# DREDGED MATERIAL MANAGEMENT PLAN AND ENVIRONMENTAL IMPACT STATEMENT

## McNary Reservoir and Lower Snake River Reservoirs

### APPENDIX A Hydrologic Analysis

**ERRATA SHEET  
FOR  
APPENDIX A - HYDROLOGIC ANALYSIS**

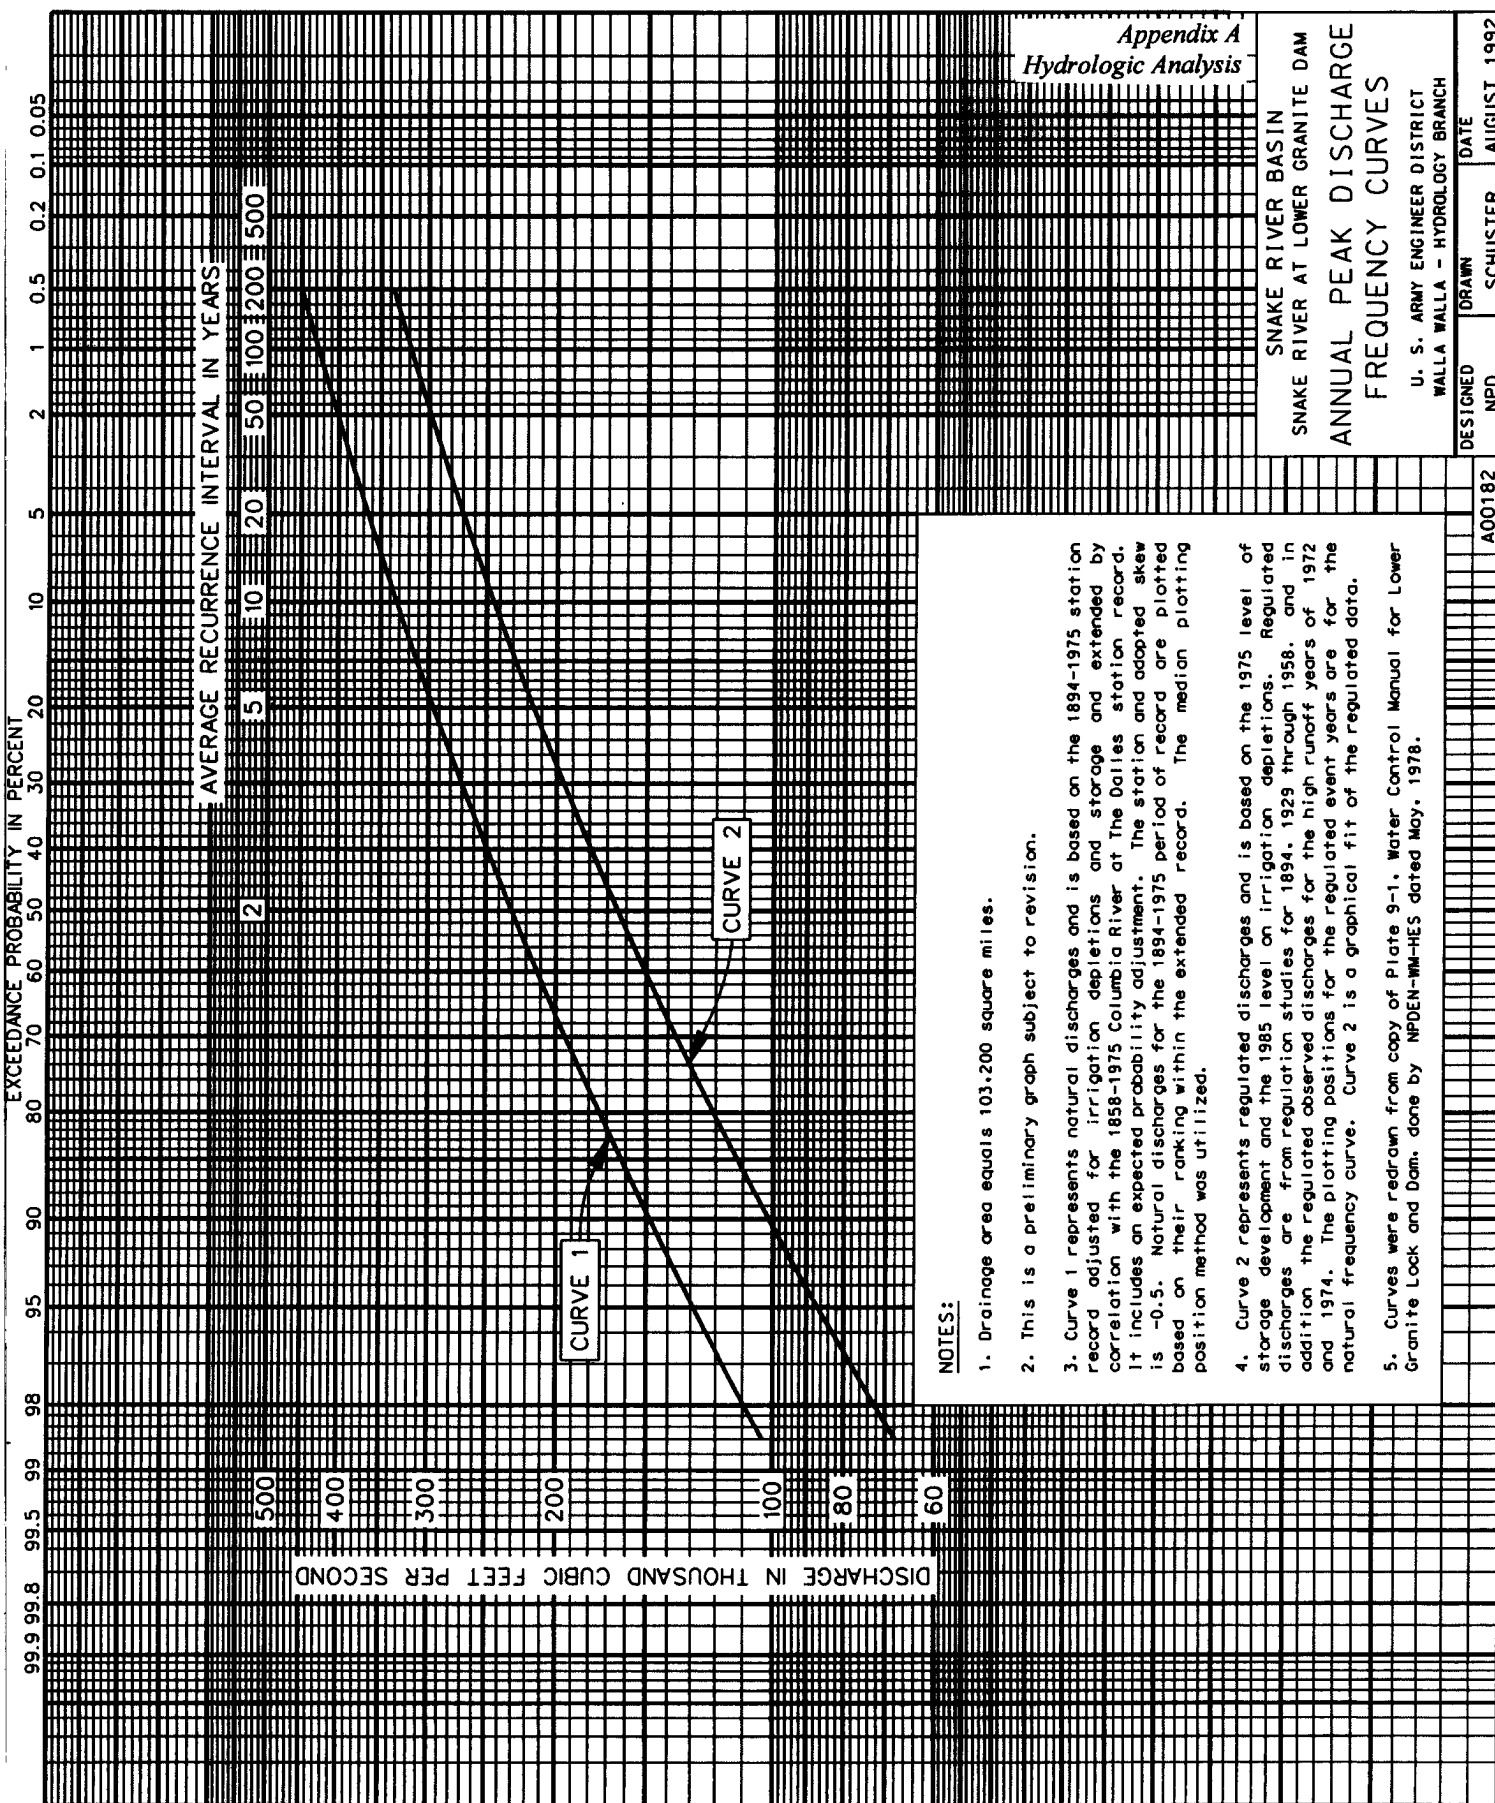
Title of Plate 5 should be: Snake River in Lower Granite Reservoir Sedimentation Ranges

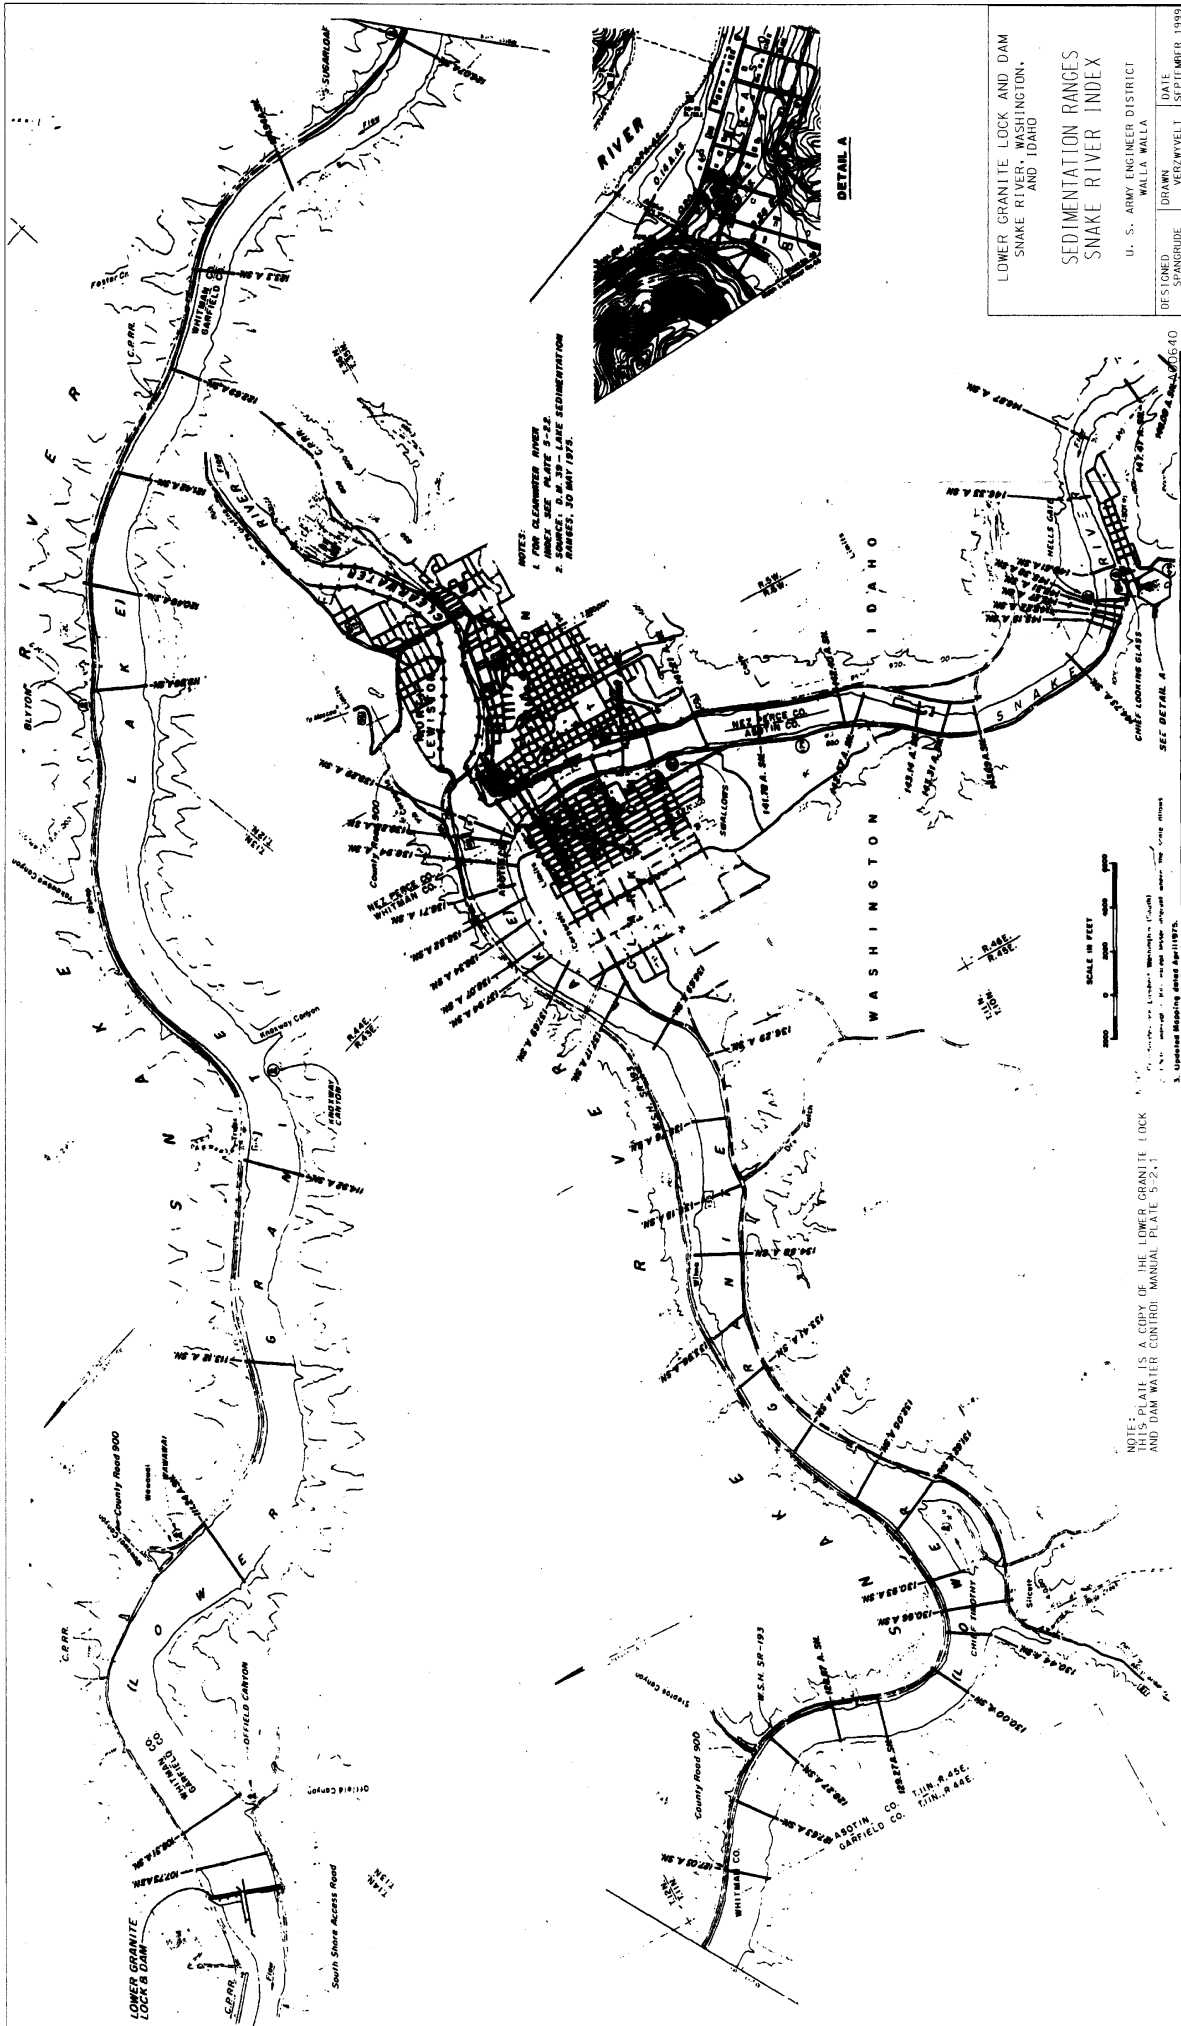
Title of Plate 6 should be: Clearwater River in Lower Granite Reservoir Sedimentation Ranges

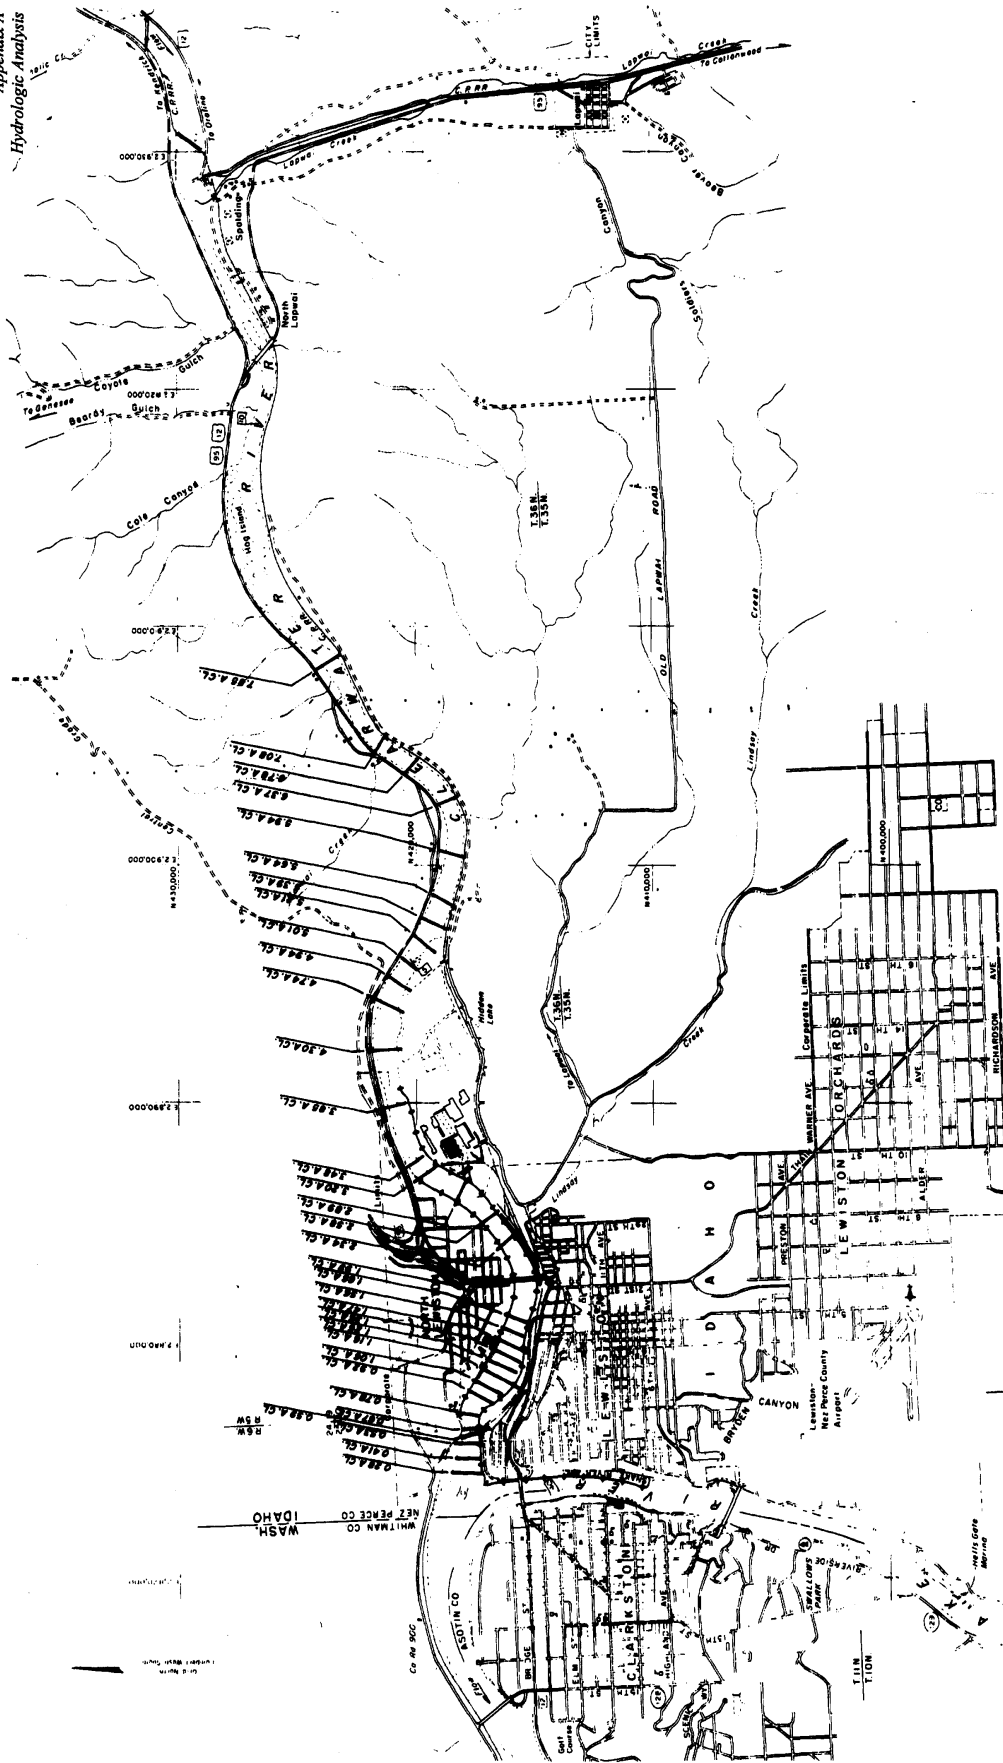
Title of Plate 7 should be: Columbia River in McNary Reservoir Sedimentation Ranges
